October 25, 2021

Ms. Karen M. Gaidasz, Chief
Offshore Wind & Hydroelectric Section
Energy Project Management Bureau
New York Department of Environmental Conservation
625 Broadway, 4th Floor
Albany, NY 12233-1750

**Re: Notice of Incomplete Application
401 Water Quality Certification & Article 15 Protection of Waters Permits
DEC # 4-0122-00322/00002
Port of Albany Expansion Project
Beacon Island Parcel, Bethlehem NY, Albany County**

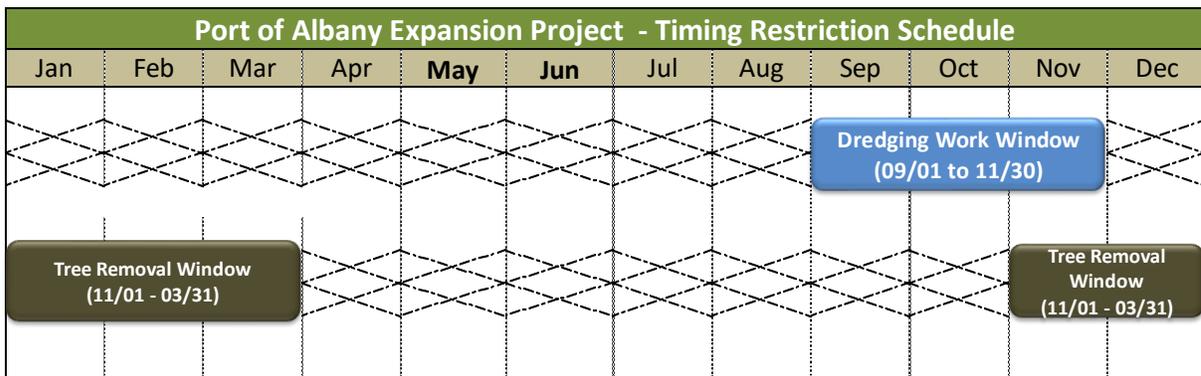
Comments # 16. *The proposed wharf dredge depth is significantly deeper than current conditions. Please describe what mitigation is proposed to offset potential impacts to shortnose sturgeon habitat.*

Response # 16: Proposed dredge depth is required to match current navigational depth of Hudson River (federal navigational channel) providing adequate separation and safe draft to vessels at the proposed wharf, and ability to the species to potentially swim under the vessels. Proposed depth is approximately 32 feet below the MLLW line, plus approximately two (2) feet of allowable overdredge.

According to the Sediment Sampling Analysis, the proposed dredging will occur over a substrate consisting of silty clay, sand and some trace of gravel, including Class C sediments. The proposed mechanical dredging would remove of approximately 105,000 cubic yards containing concentrations of pesticides and PCBs contributing to the cleanup and improving the quality of the Hudson River.

DRAWING TITLE
SECTION VIEWS

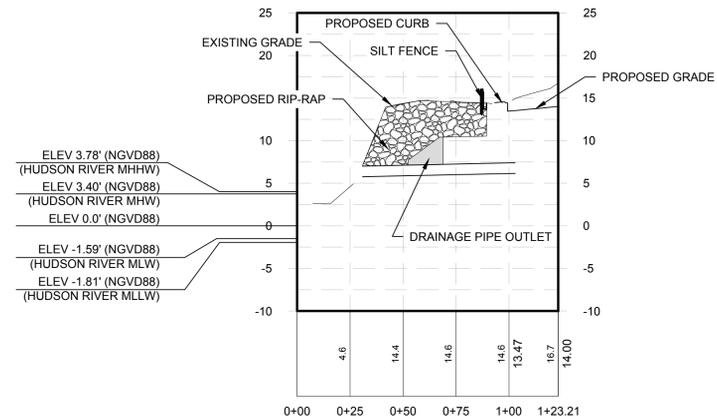
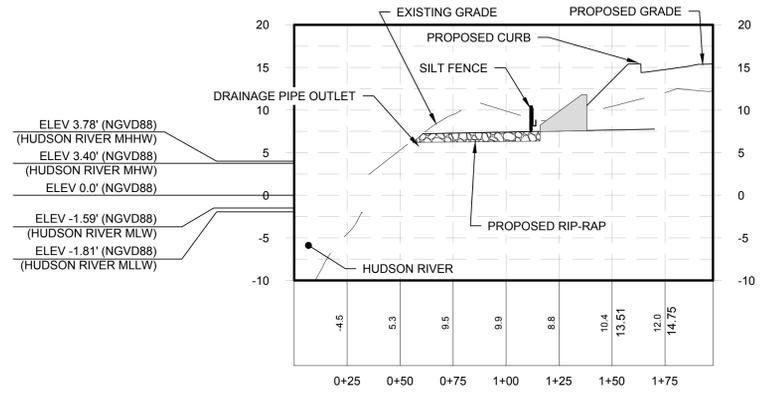
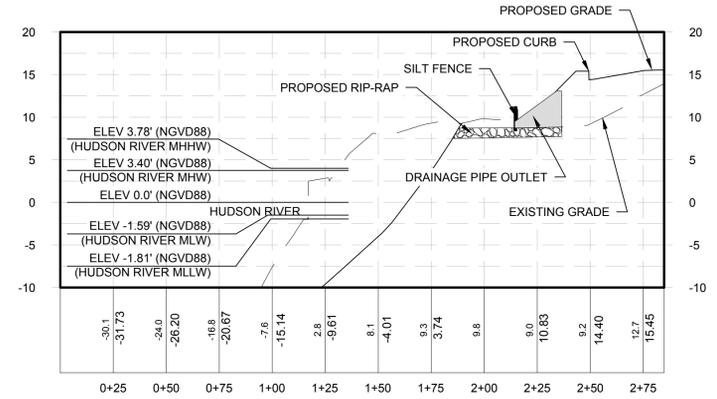
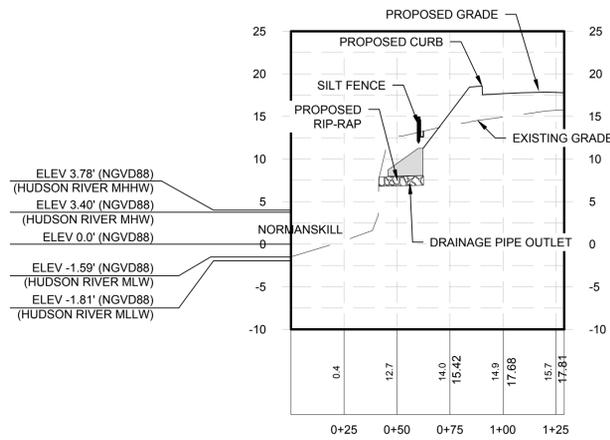
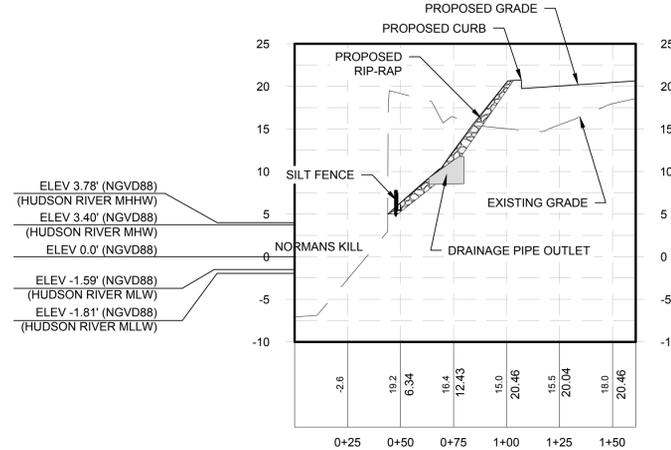
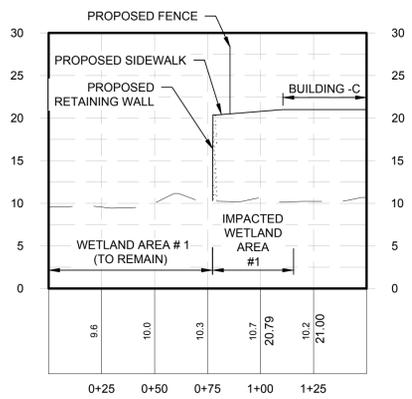
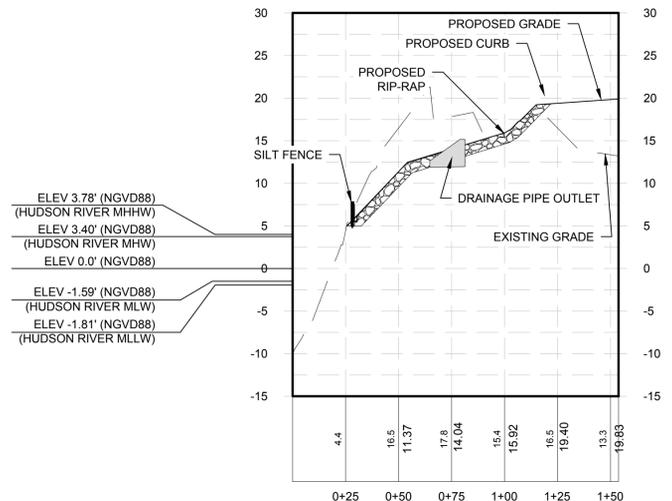
Comments # 11. *Cross-sections of the outfalls on the Normans Kill and Hudson River shorelines should be included in the site plans.*

Response # 11: See **Exhibit 1** for revised plans (Permit Set).

SCALE: AS SHOWN	DATE: JULY 2021	FIGURE: 3-1

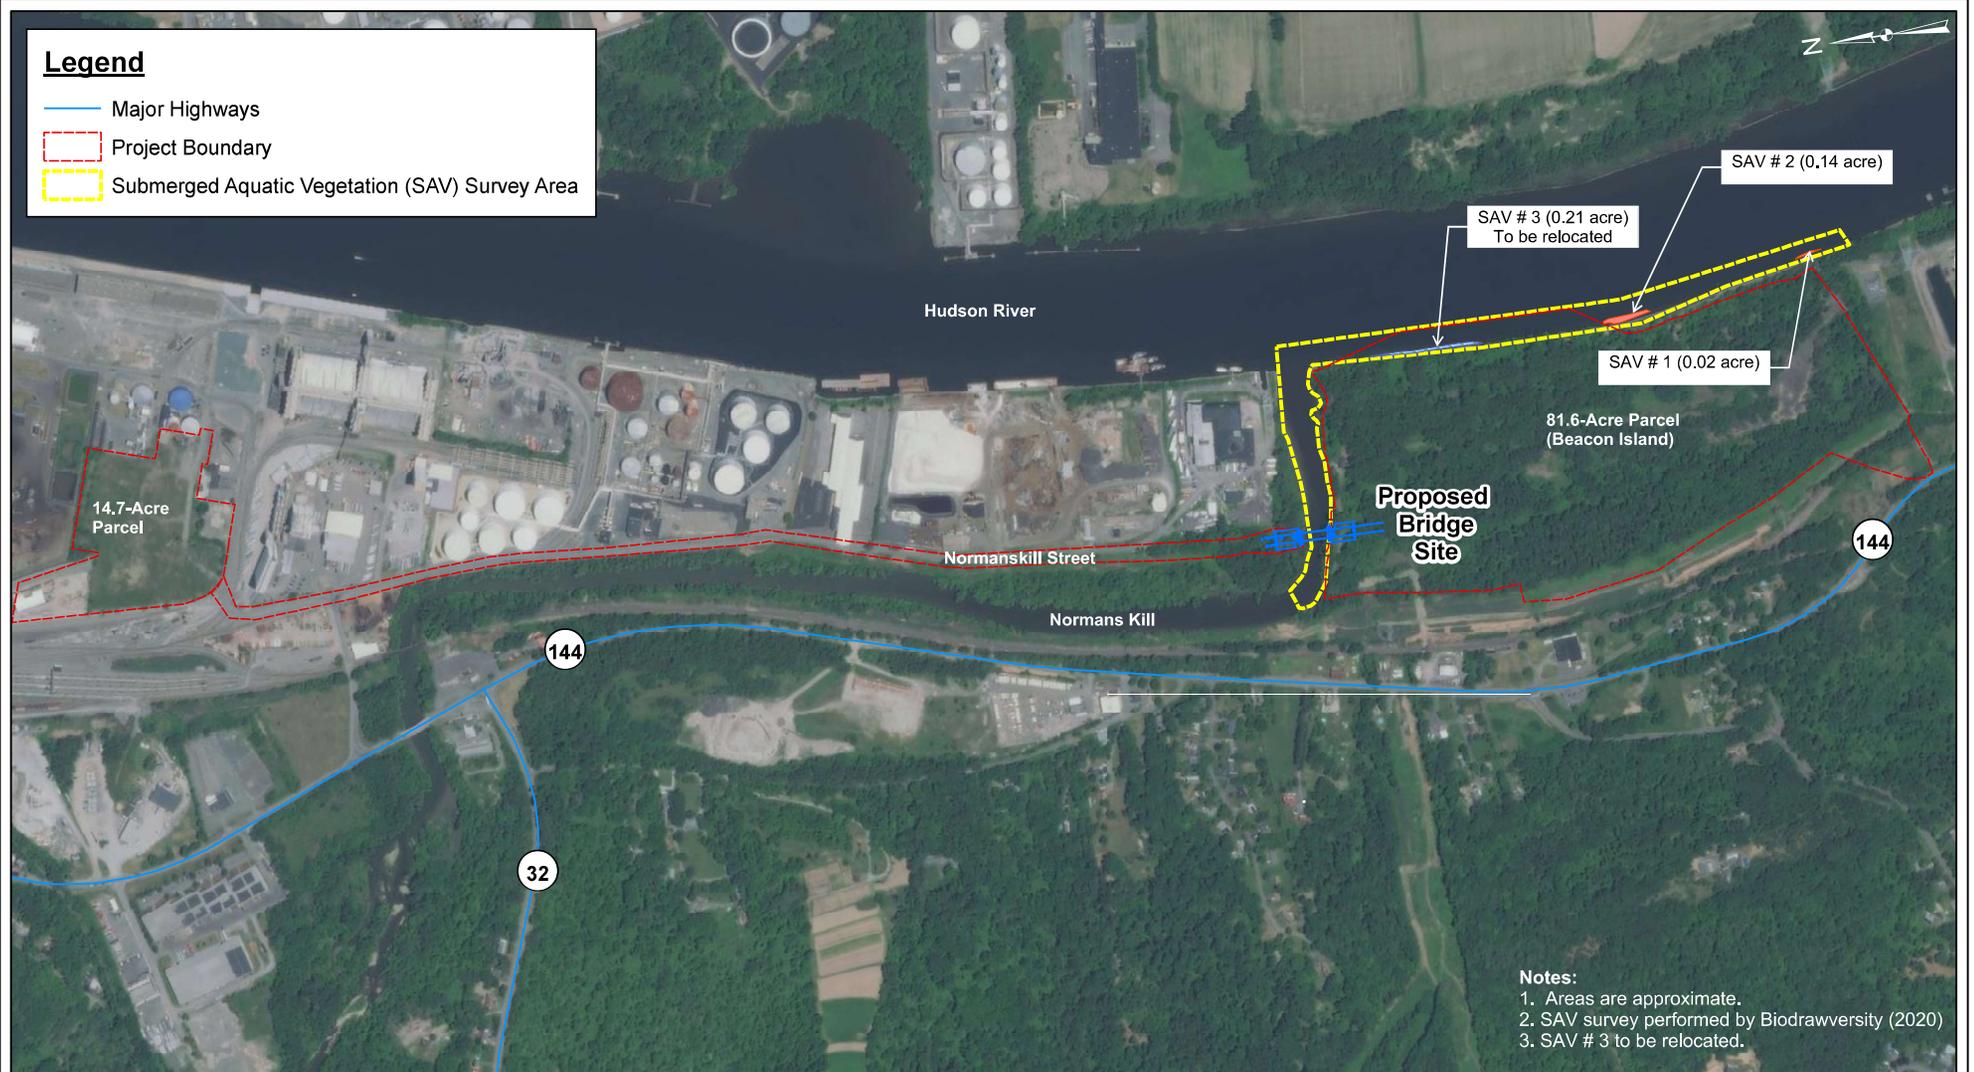
Comment # 34. *Please provide a SAV relocation plan for NYSDEC staff review.*

Response # 34: The relocation plan for *V. americana* was presented under Section 6.2.2. The mitigation plan consists of transplanting *V. americana* from SAV patch # 3 to SAV beds and adjoining areas (FSM Sections 1 to 7) outside the project limits, seeking to promote a continuous bed. SAV beds (patches 1 and 2) would be protected. SAV Transplanting Plan is also enclosed as **Exhibit 5**.

In accordance with NYSDEC letter dated August 29, 2020 (DEC #4-0122-00322/00001), *V. americana* from SAV patch # 3 would be transplanted to SAV beds and adjoining areas (FSM Sections 1 to 7) outside the project limits, seeking to promote a continuous bed. SAV beds (patches 1 and 2) are to remain and not to be impacted by the Project. See **Appendix 1** (Permit Sketches). Following is describe the transplanting approach for *V. americana*. See **Figure 3-1** for SAV areas and **Figure 3-2** for location of FSM Sections.

SCALE: AS SHOWN	DATE: JULY 2021	FIGURE: 3-2

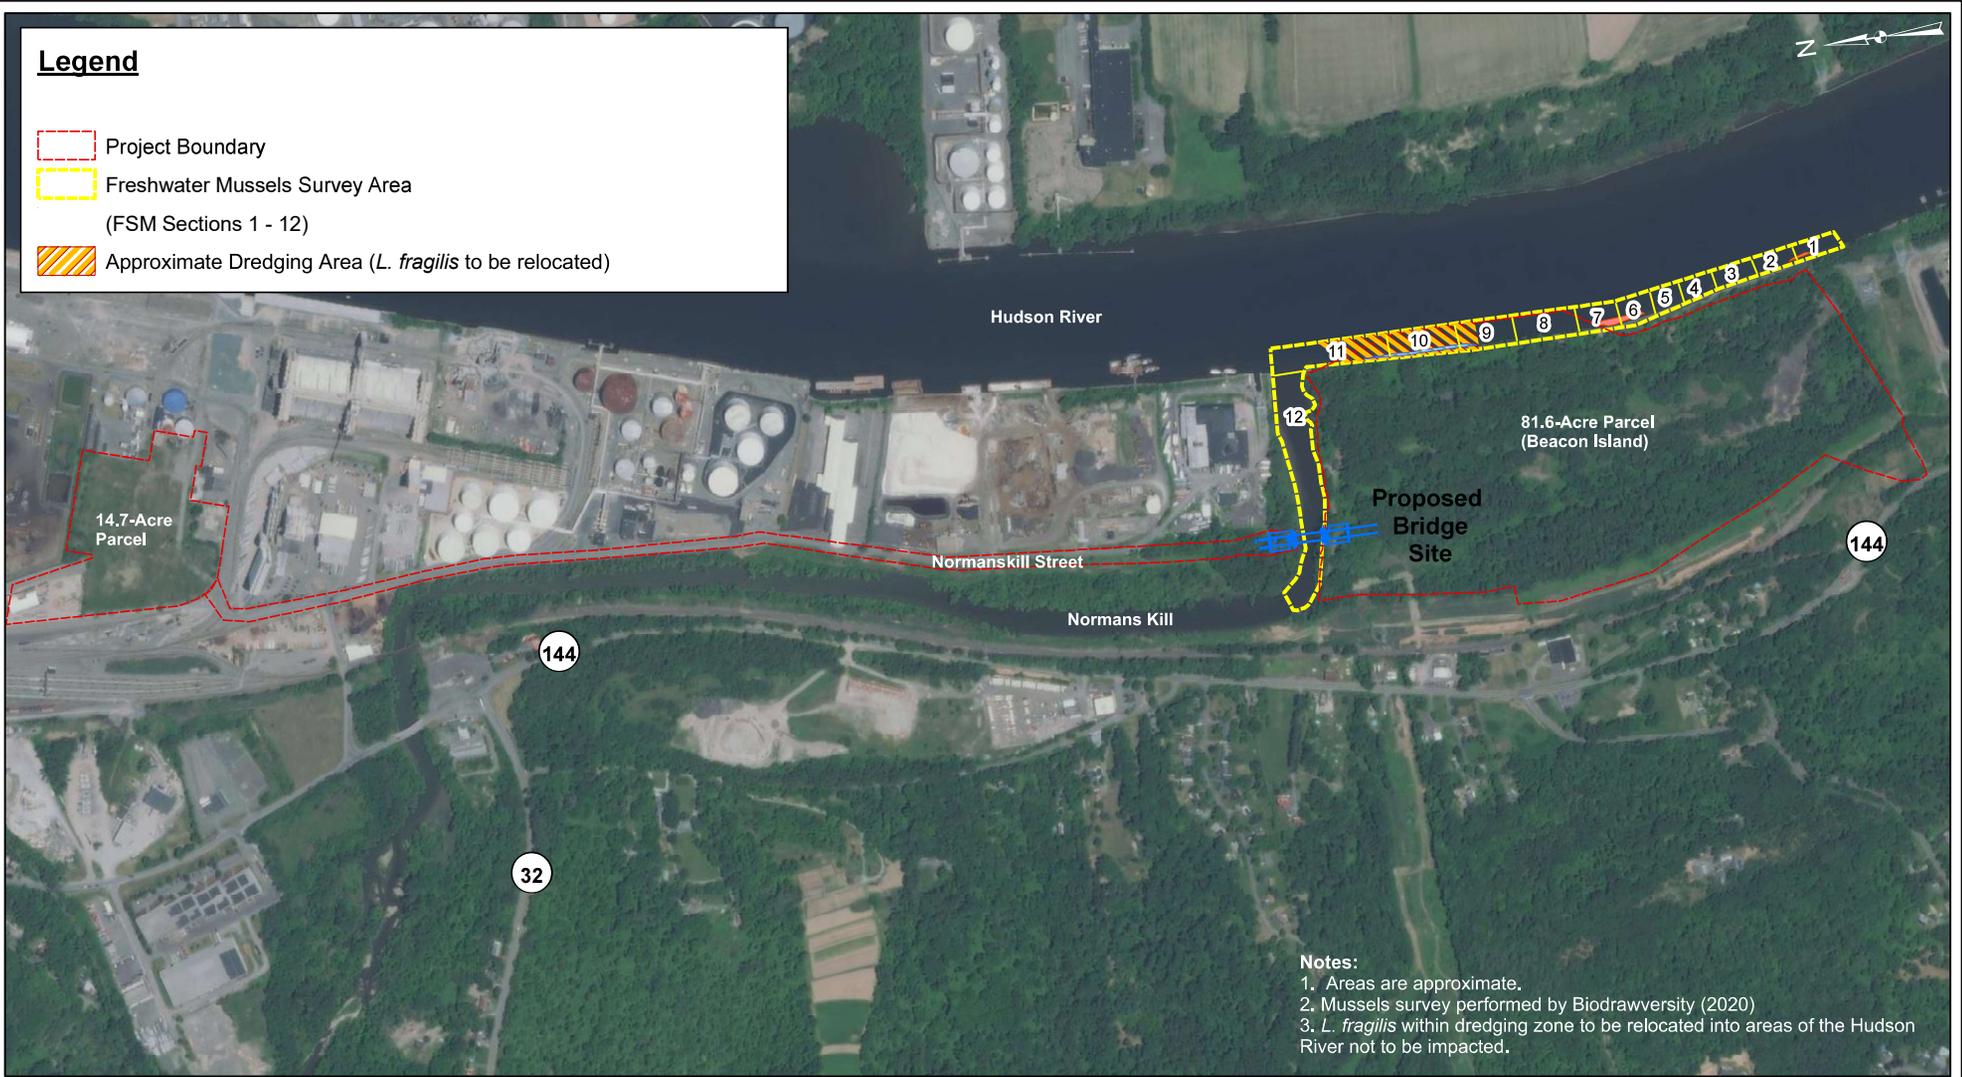
Comment # 35. *The application states, “[t]he SAV transplanting efforts would be conducted in coordination with the mussel relocation.” Please clarify if the Mussel and SAV relocation are intended to occur at the same time in one effort.*

The SAV transplanting efforts would be conducted between late spring and early summer, ahead of the dredging schedule. It is anticipated that the SAV relocation would be conducted in one mobilization outside the dredging work window. The relocation team would mobilize prior to any in-water work construction activities (e.g., dredging) to complete the collection of SAV and relocation of the species to the SAV patch # 1 and patch # 2. The qualified personnel would conduct and supervise the overall SAV relocation activities. See **Figure 3-1** for SAV Areas and **Figure 3-2** for location of FSM Sections.
